WATERVIEW EAST COMMERCIAL

GRADING AND EROSION CONTROL PLANS

Revise title to "Pre-subdivision Grading and Erosion Control Plans"

SHEET
C 3.1

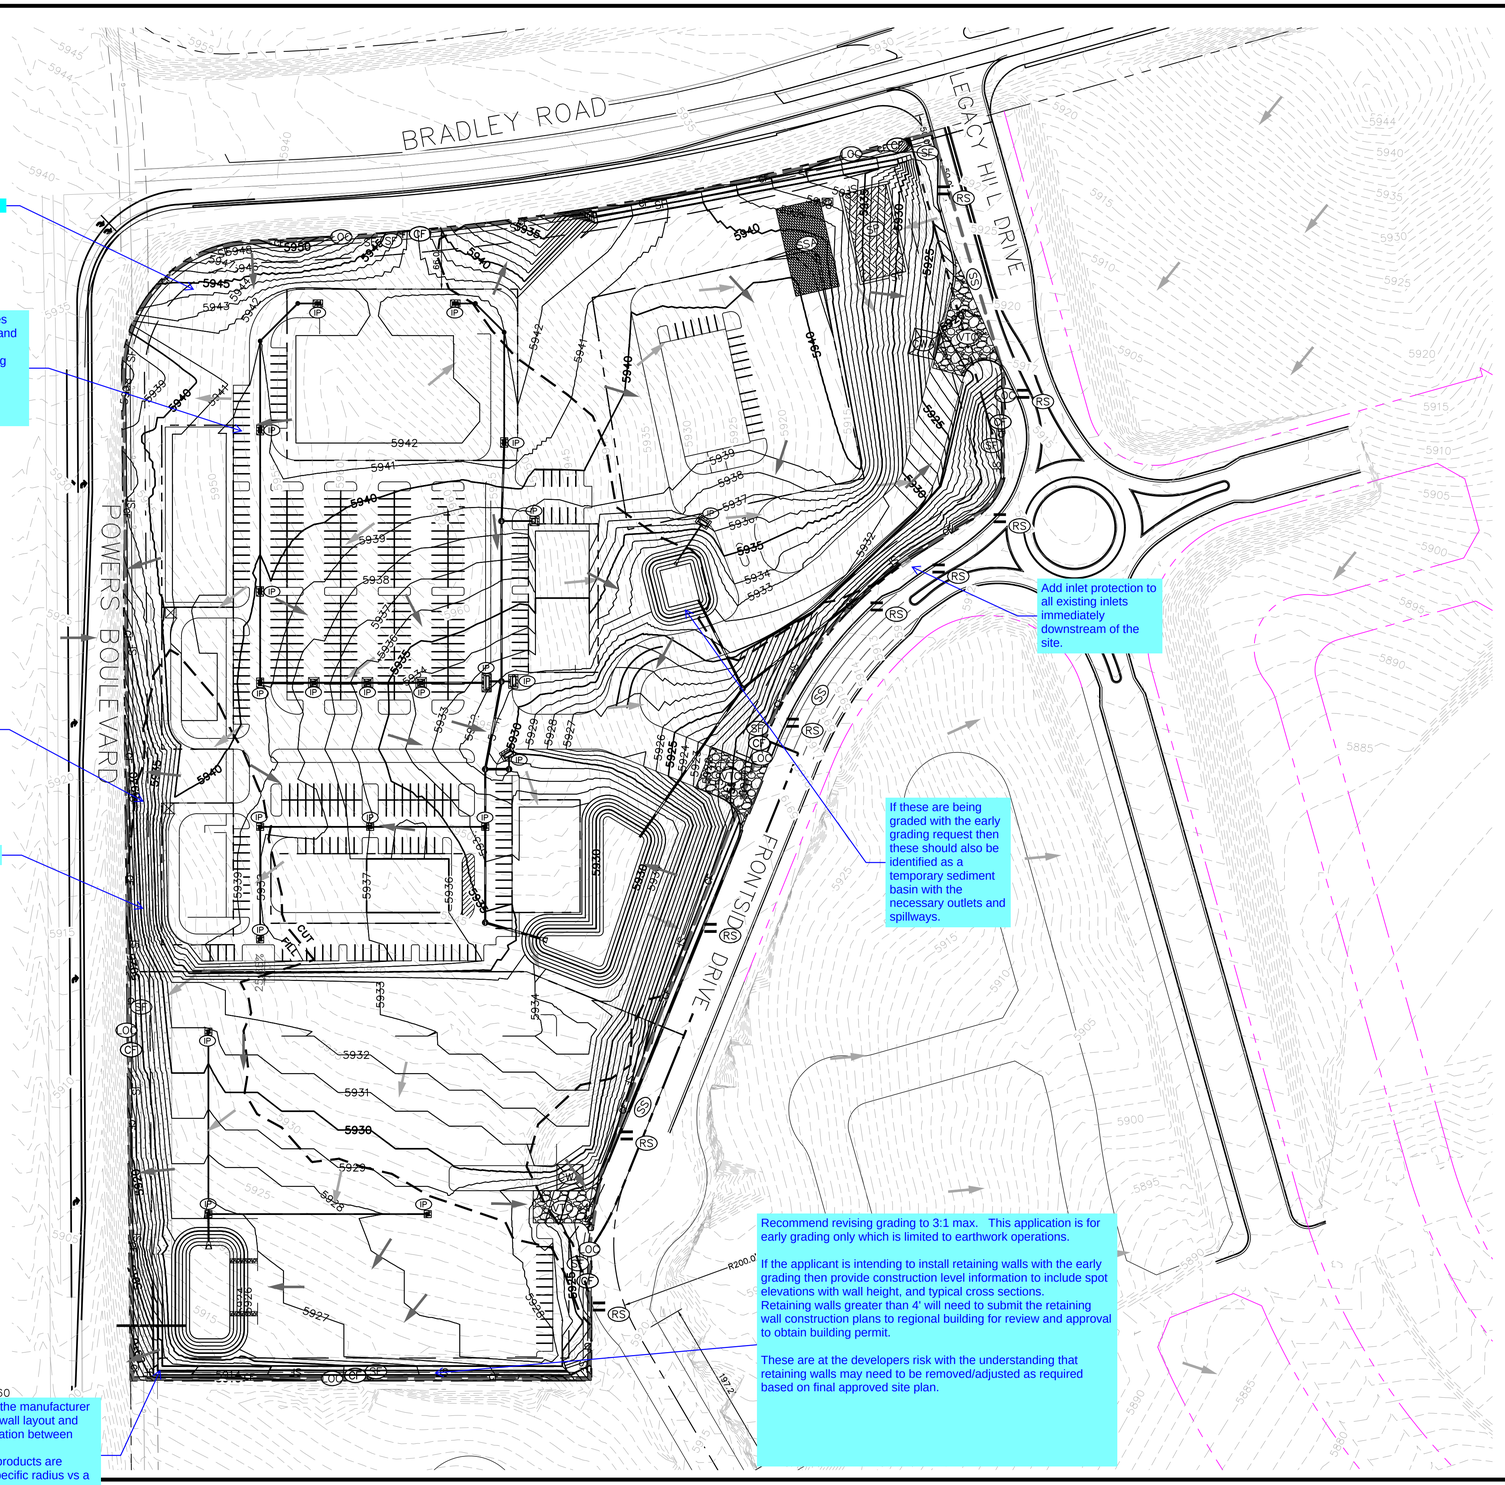
Temporary Seeding

Indicate seeding areas

Turn off all proposed infrastructures (C&G, Striping, stormdrain pipes, and inlets).
This application is for early grading only which is limited to earthwork operations.

Did not see any diversion ditches on the plan. Please show clearly and include detail or remove from legend

Slopes steeper than 3:1 will need blanket protection

label slopes.

Coordinate with the manufacturer on the retaining wall layout and horizontal separation between tiers.
Typically these products are designed at a specific radius vs a 90d bend.

Add inlet protection to all existing inlets immediately downstream of the site.

If these are being graded with the early grading request then these should also be identified as a temporary sediment basin with the necessary outlets and spillways.

Recommend revising grading to 3:1 max. This application is for early grading only which is limited to earthwork operations.

If the applicant is intending to install retaining walls with the early grading then provide construction level information to include spot elevations with wall height, and typical cross sections.
Retaining walls greater than 4' will need to submit the retaining wall construction plans to regional building for review and approval to obtain building permit.

These are at the developers risk with the understanding that retaining walls may need to be removed/adjusted as required based on final approved site plan.

SHEET
C 3.2

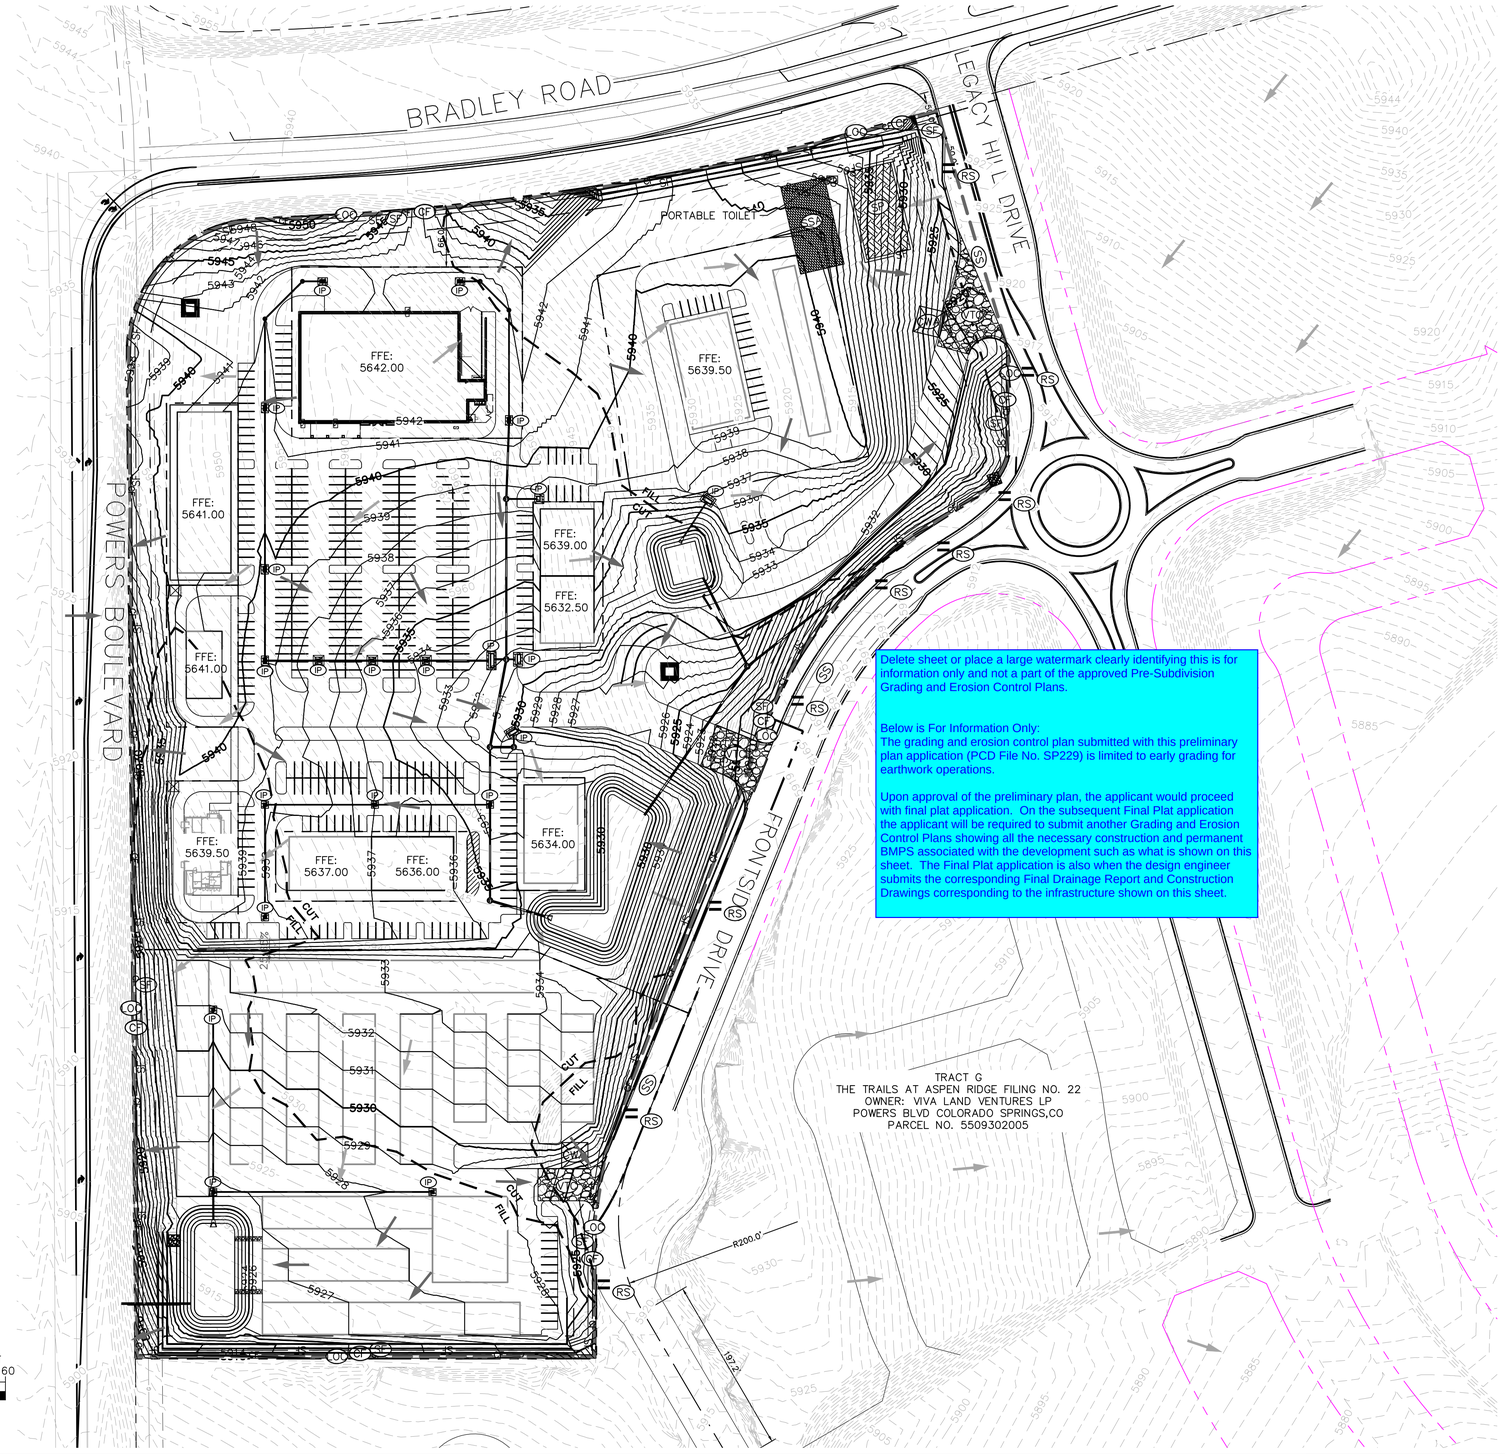
Make sure that this gets included with the final plat application.

Delete sheet or place a large watermark clearly identifying this is for information only and not a part of the approved Pre-Subdivision Grading and Erosion Control Plans.

Below is For Information Only:
The grading and erosion control plan submitted with this preliminary plan application (PCD File No. SP229) is limited to early grading for earthwork operations.

Upon approval of the preliminary plan, the applicant would proceed with final plat application. On the subsequent Final Plat application the applicant will be required to submit another Grading and Erosion Control Plans showing all the necessary construction and permanent BMPS associated with the development such as what is shown on this sheet. The Final Plat application is also when the design engineer submits the corresponding Final Drainage Report and Construction Drawings corresponding to the infrastructure shown on this sheet.
